MPS Baseline proposal

v260

Lennart Yseboodt, Philips

David Abramson, Texas Instruments

Table 33–19—PD Maintain Power Signature

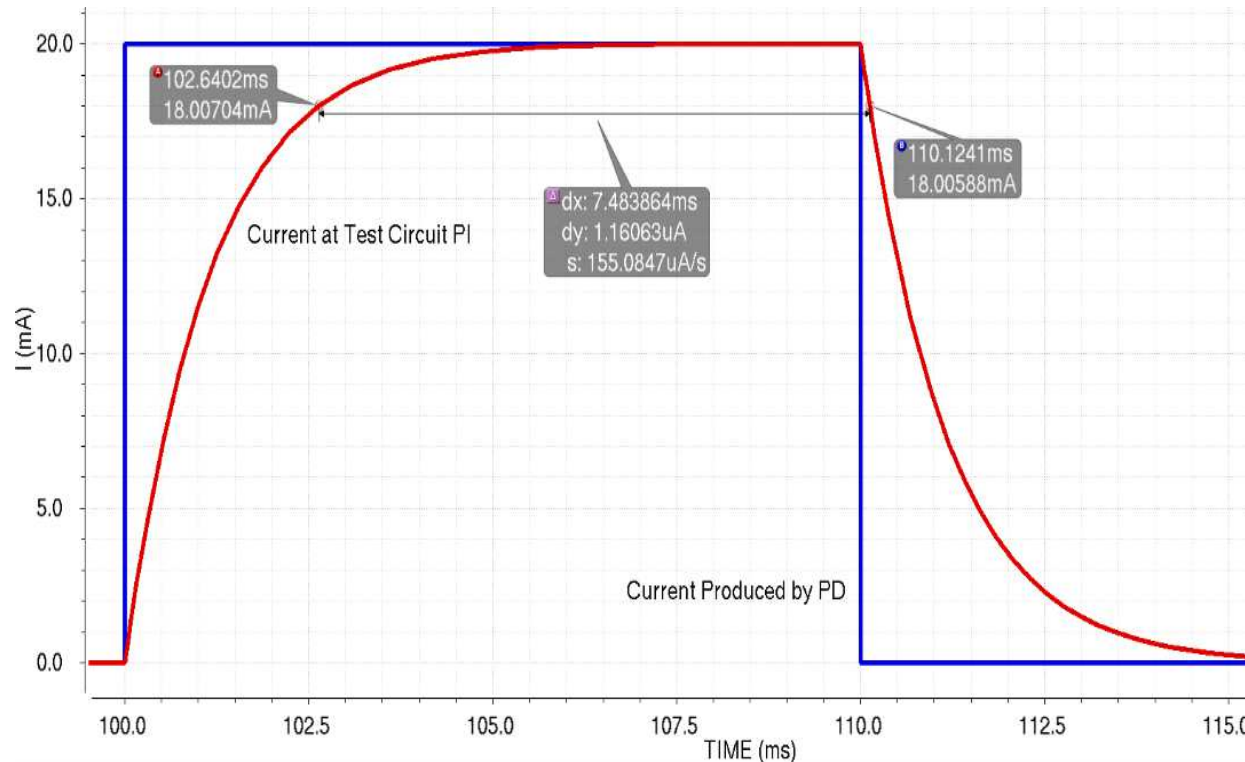
- a) Current draw equal to or above **10 mA** for a minimum duration of **75 ms, measured at the PD PI**, followed by an optional MPS dropout for no longer than 250ms **when connected to a Type 1 or 2 PSE, and**
- b) Current draw equal to or above **TBD mA** for a minimum duration of **7 ms, measured with series resistance representing the worst case cable impedance between the measurement point and the PD PI**, followed by an optional MPS dropout for no longer than **318 ms when connected to a Type 3 PSE. See Annex 33B(TBD) for PD design guidelines for MPS behavior.**

In addition, the MPS for all PDs shall have input impedance with resistive and capacitive components as defined in Table 33–19.

A PD that does not maintain the MPS components ~~in a) and b)~~ above may have its power removed within the limits of T_{MPDO} as specified in Table 33–11.

Powered PDs that no longer require power shall remove both **the current draw and impedance** components ~~a) and b)~~ of the MPS. To cause PSE power removal, the impedance of the PI should rise above Z_{ac2} as specified in Table 33–12.

NOTE—A **Type 1 or 2** PD with $C_{port} > 180 \mu\text{F}$ **or Type 3 PD with $C_{port} > \text{TBD uF}$** may not be able to meet the MPS current draw specifications during the maximum allowed port voltage droop ($V_{Port_PSE \text{ max}}$ to $V_{Port_PSE \text{ min}}$ with series resistance R_{Ch}). Such a PD should increase its $I_{Port \text{ min}}$ or make other such provisions to meet the Maintain Power Signature.
